SUNNICA ENERGY FARM

EN010106

8.52 Update by the Applicant on Heritage Matters and Substation
Connection

| Version | Date | Status of Version |
|----------------|------------------|--------------------------|
| Rev 00 | 28 November 2022 | Deadline 3A Submission |

Drawing Title
B50 CRASH SITE EXCLUSION AREA

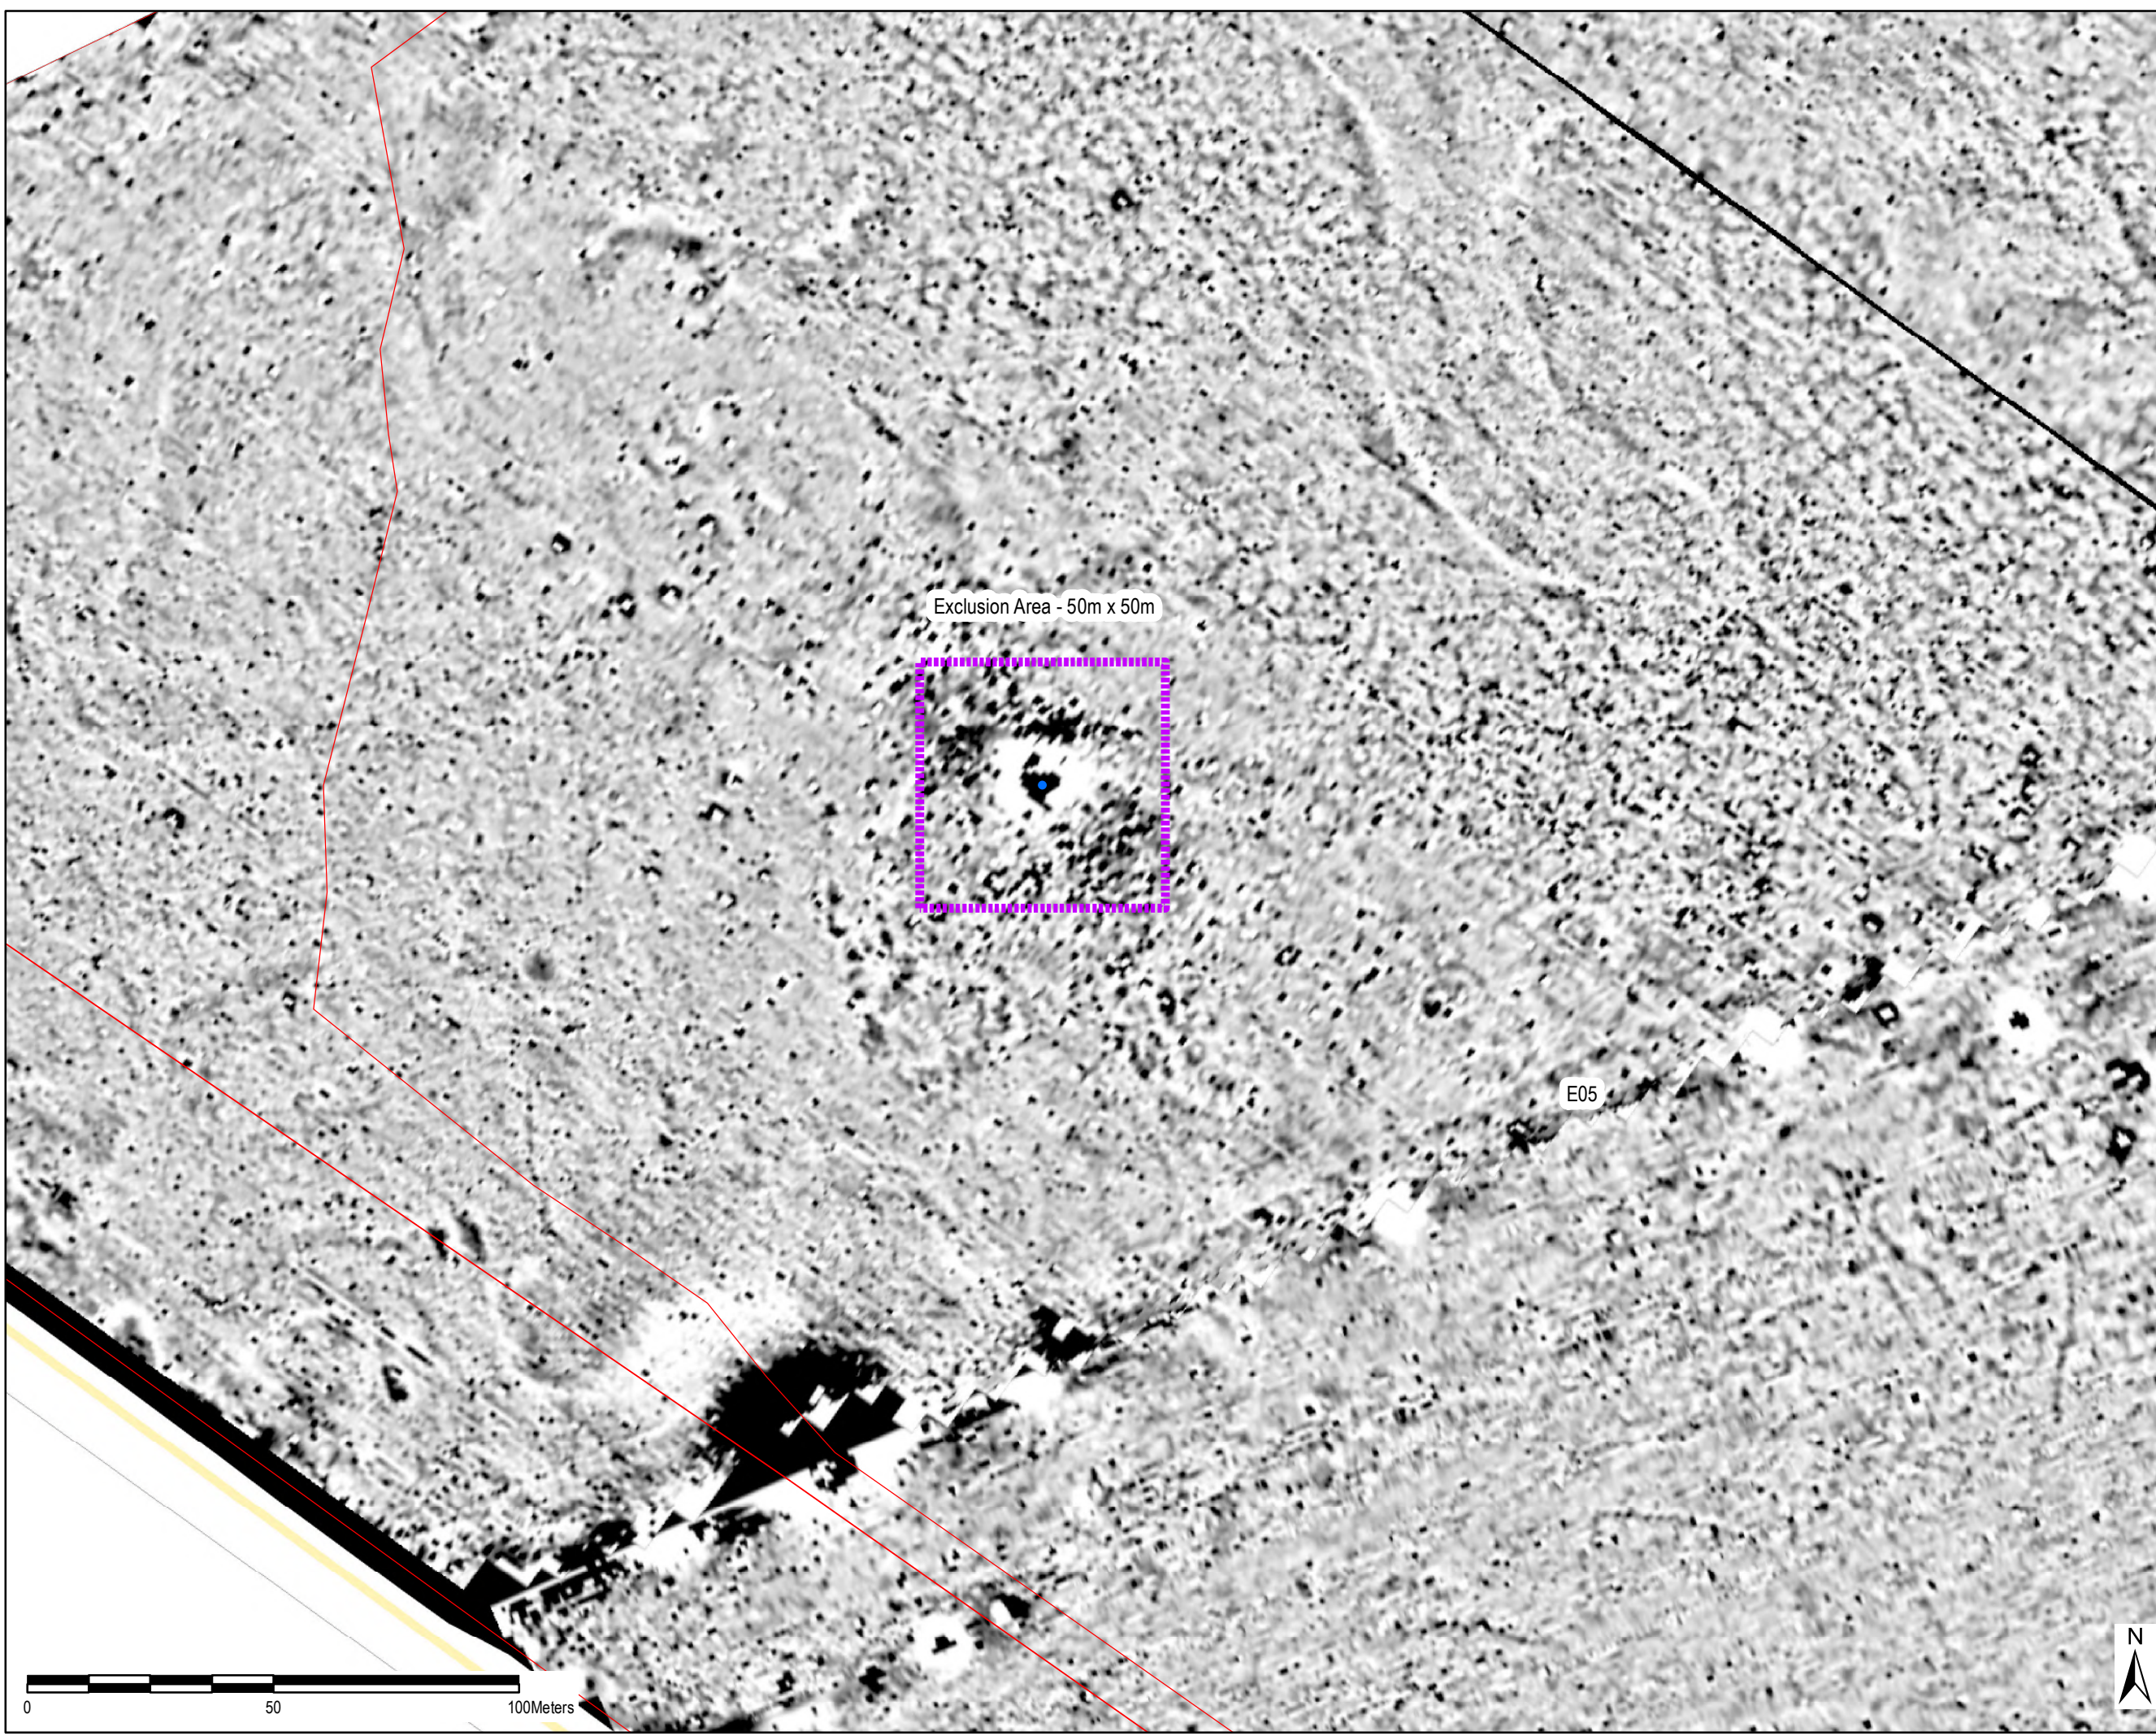
- 4.1.9 The Applicant agrees that the crash crater is an important location and the immediate area over the crater should be excluded from development. The exclusion zone over the crater would be to preserve a physical, though not visible, feature relating to the tragedy. The exclusion zone could also be subtly marked as part of the development design to be locatable when viewing from the proposed information board and commemorative plaque. Development of arrays around the exclusion zone will not impact the significance of the event or the location.

4.1.15 The 'crash site exclusion area' is the immediate area over the crater referred to in paragraph 4.1.9 which is excluded in all circumstances. That is shown on Plan A to this note, which will be certified by the DCO, and is a 50m box encompassing the area formed by the crash crater.

- (1) No part of the authorised development may take place within the crash site exclusion area.*
- (2) Work No. 1A must not commence until the undertaker has confirmed to Cambridgeshire County Council that either-*

- 4.1.20 The removal of the "crash site exclusion area" will, however, form part of the Changes Application discussed below as that is a commitment the Applicant is willing to give now.

Drawing Title
**B50 CRASH SITE
POTENTIAL EXPANDED
CRASH SITE EXCLUSION AREA**

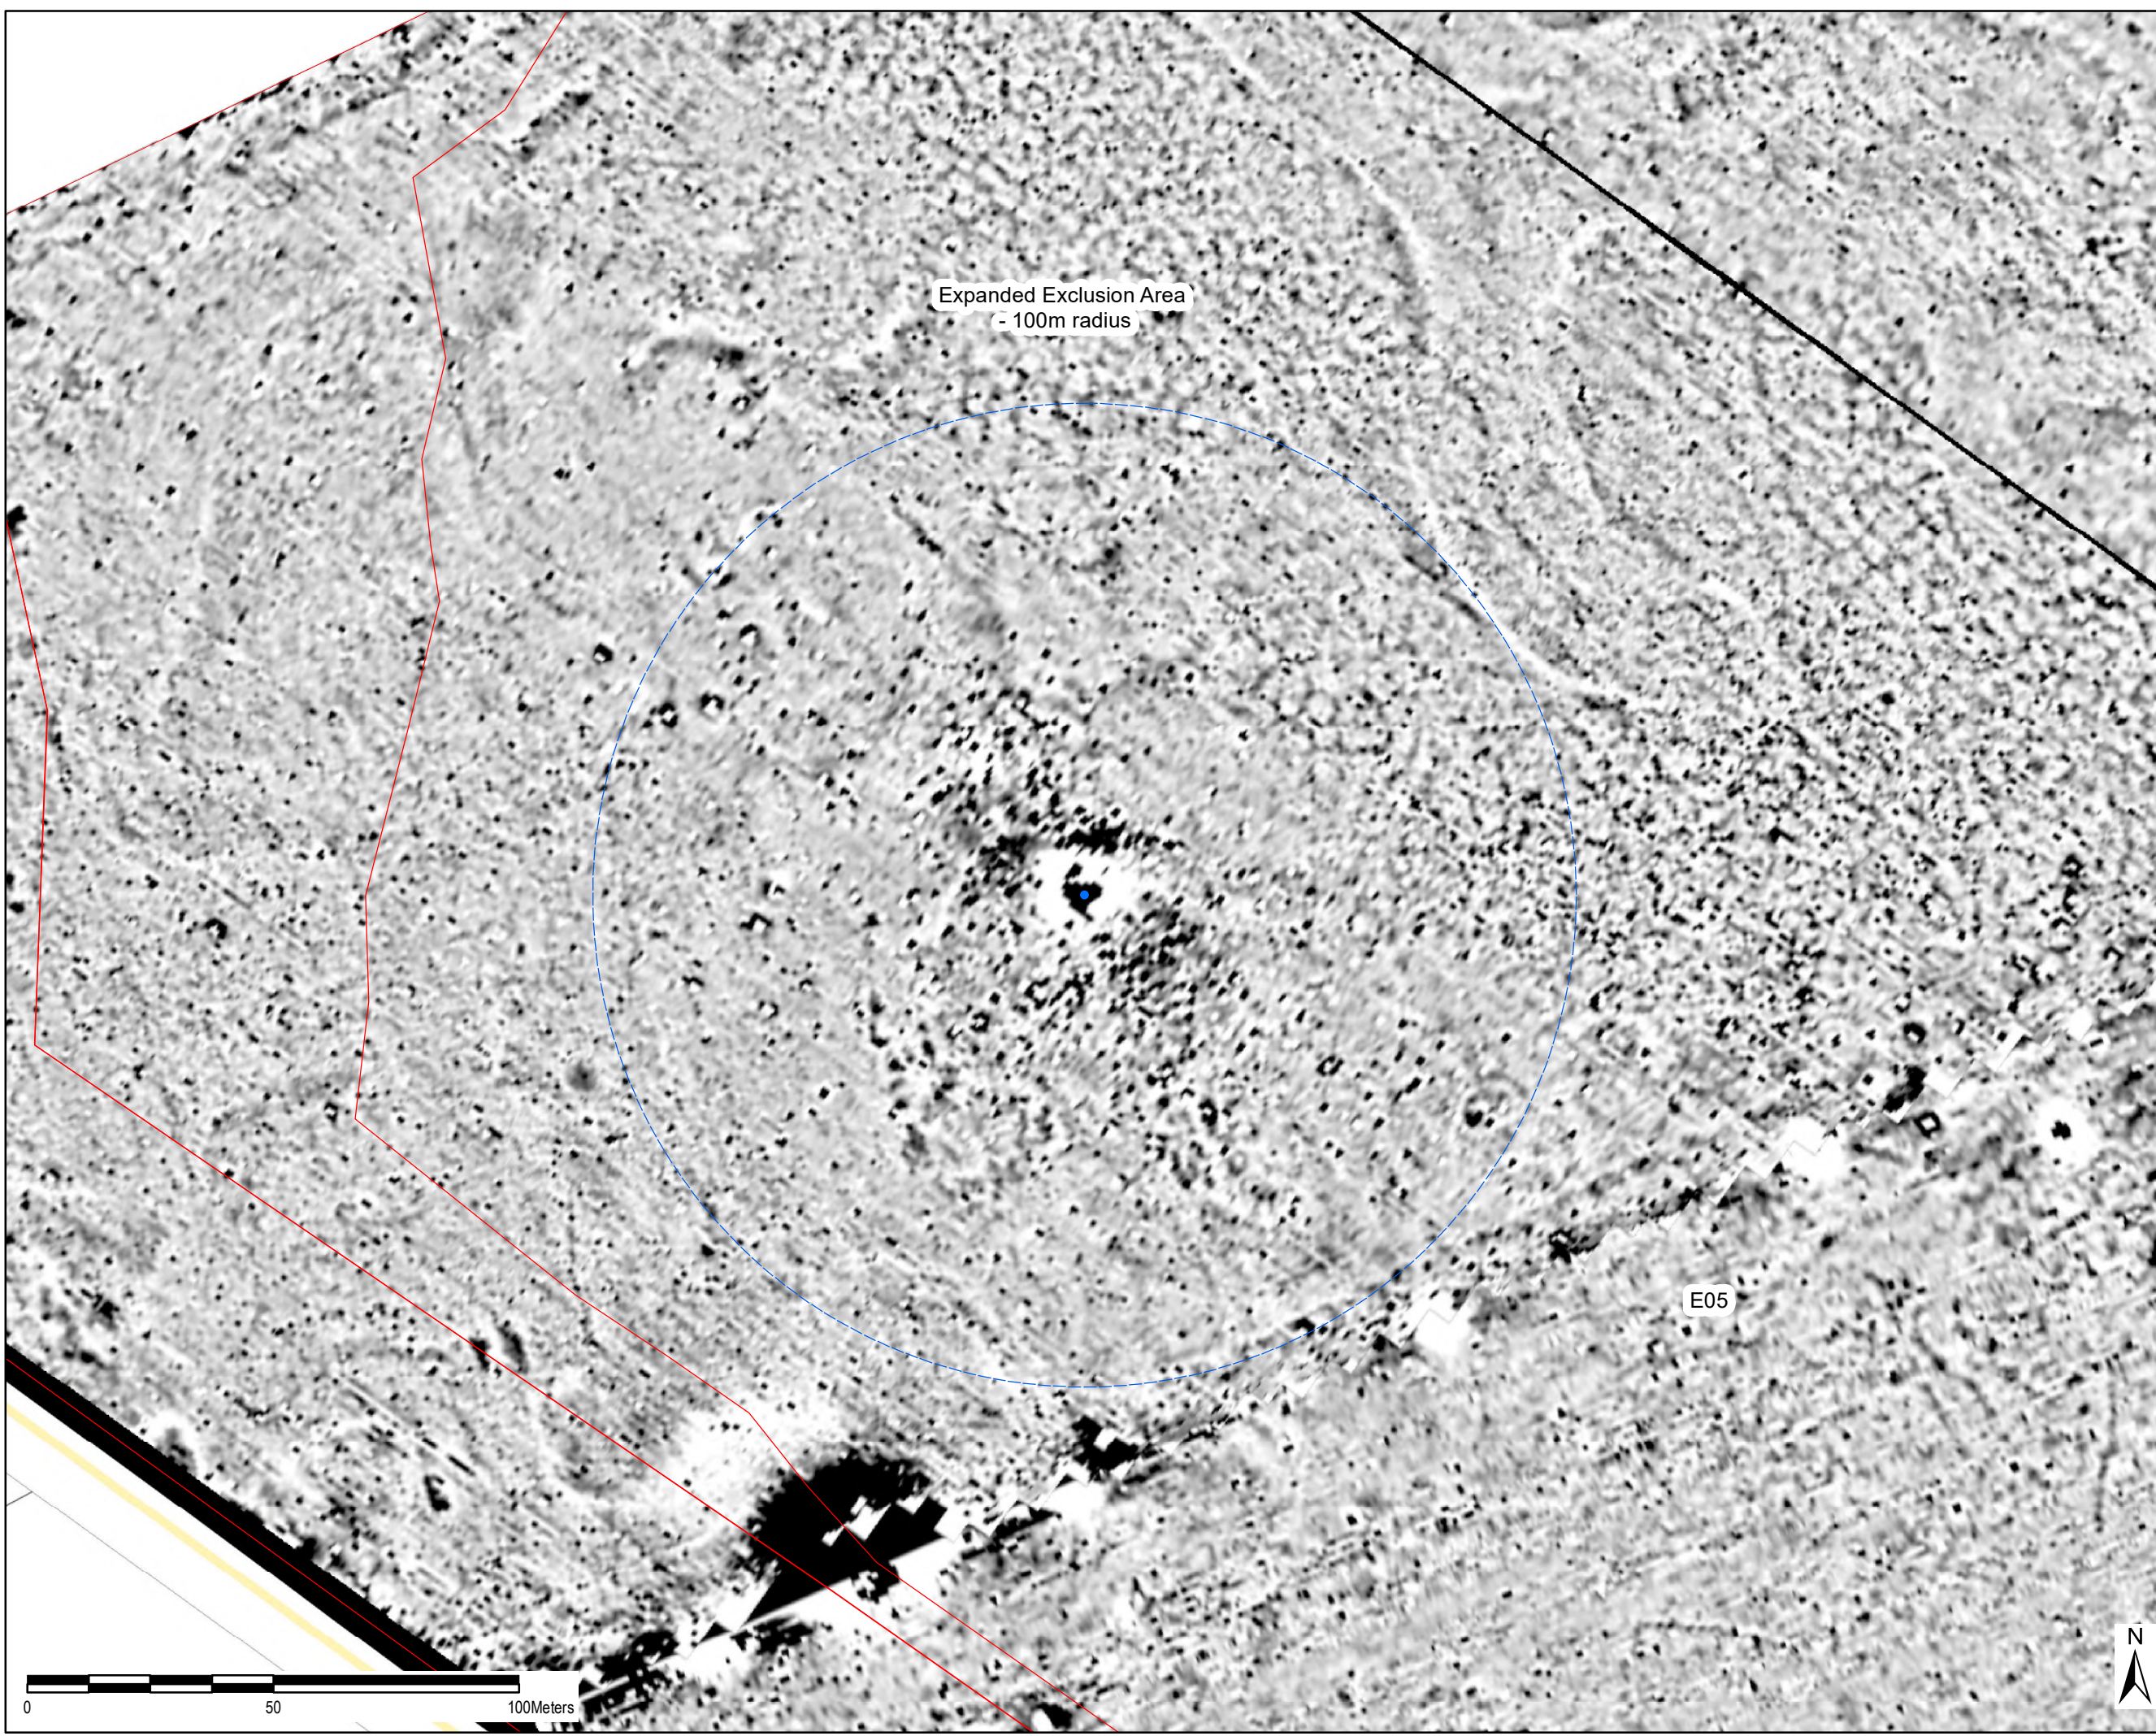
4.1.16 The 'potential expanded crash site exclusion area' referred to in that draft Requirement is the area set out in Plan B to this note. This area would be within a 100m radius from centre point of the crash site (the crater), which is an area consistent with the area that JCCC's licenses seek to protect.

- a. the power generation created by the Scheme would be reduced by the total of the area within the 100m radius from the centre point which is approximately 3.14 Ha. Therefore, an estimate of approximately 3.1MWp of installed capacity solar PV would be removed from the overall installed capacity of the Scheme.

- (a) a licence under the Protection of Military Remains Act 1986 has been obtained in respect of the carrying out of Work No. 1A within the potential expanded crash site exclusion area; or*

- e. *(b) a licence under the Protection of Military Remains Act 1986 has not been obtained in respect of the carrying out of Work No. 1A and that therefore no part of the authorised development will take place within the potential expanded crash site exclusion area.*

- (3) If the undertaker makes a confirmation under sub-paragraph (b) then no part of the authorised development shall take place within the potential expanded crash site exclusion area.*
